Interactive comment on “Determining regional limits and sectoral constraints for water use under climate change” by T. K. Lissner et al.

1 Reply to Reviewer # 3

Interactive comment on Hydrol. Earth Syst. Sci. Discuss., 11, 4695, 2014.

Fig. 1. Comparison of results of municipal water adequacy (upper panels) and overall water adequacy (lower panels) with variations of ± 0.2 of gamma-values for the aggregation of municipal water adequacy.

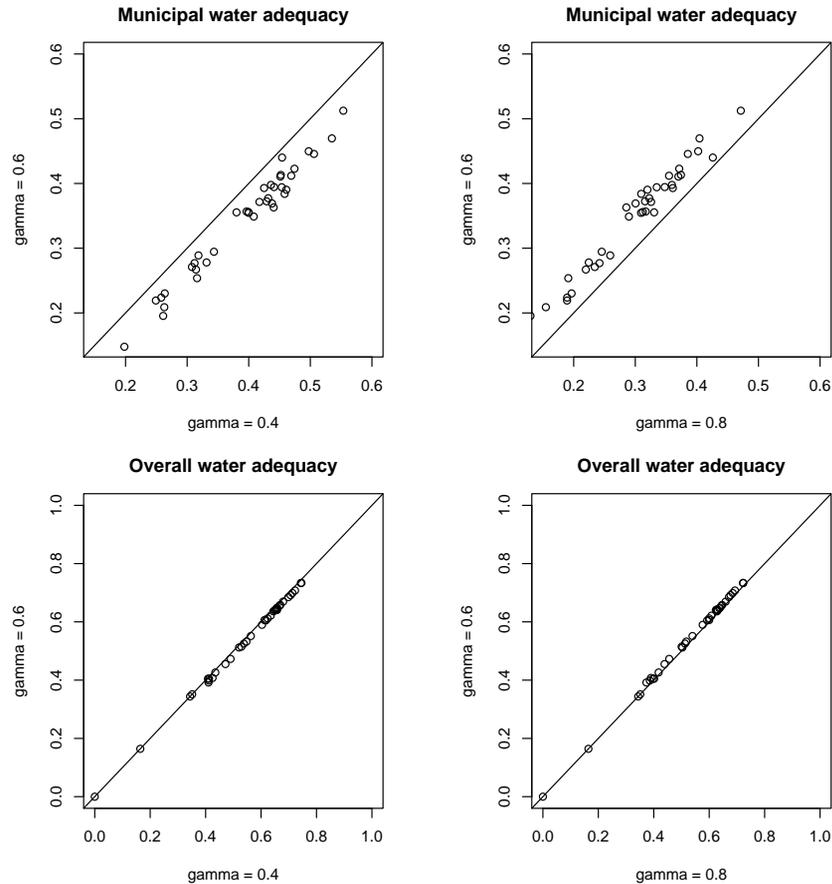
I am less familiar with the Fuzzy Logic theory, but the results seem to be very much sensitive to the weights assigned to the various indicators. The paper is full of subjective assumptions of what weight factor is used (0,0.2,0.4,0.5,0.6,0.8,1.0) and it is not clear how sensitive the results are to those assumptions.

The reviewer raises a very important point here. Assumptions underlie the definitions of each specific values within the framework, including the thresholds to define membership, fuzzy operators, the values of gamma or the chosen input data. The choice of these values is clearly important, as they determine the final result.

One of the main advantages of fuzzy logic is the possibility to account for vagueness, which is associated with the system of analysis, while nonetheless allowing for a quantification. We choose to assess range of adequacy, which allow to account for a gradual assessment of conditions, allowing for vagueness and uncertainties associated with strict thresholds. Every exact number used in the framework is therefore uncertain. However, the order of magnitude and direction of each value is motivated through the context and properties of the variables. A full sensitivity analysis for the whole assessment framework is beyond what can be done within this publication, since a large number of factors will have to be checked for sensitivity and presenting the resulting complex information is rather topic of an entire publication. However, we tested the impact of our assumptions on the final result. The attached figure (Fig.1) exemplifies for the municipal sector, how results change with a variation of gamma at +/- 0.2.
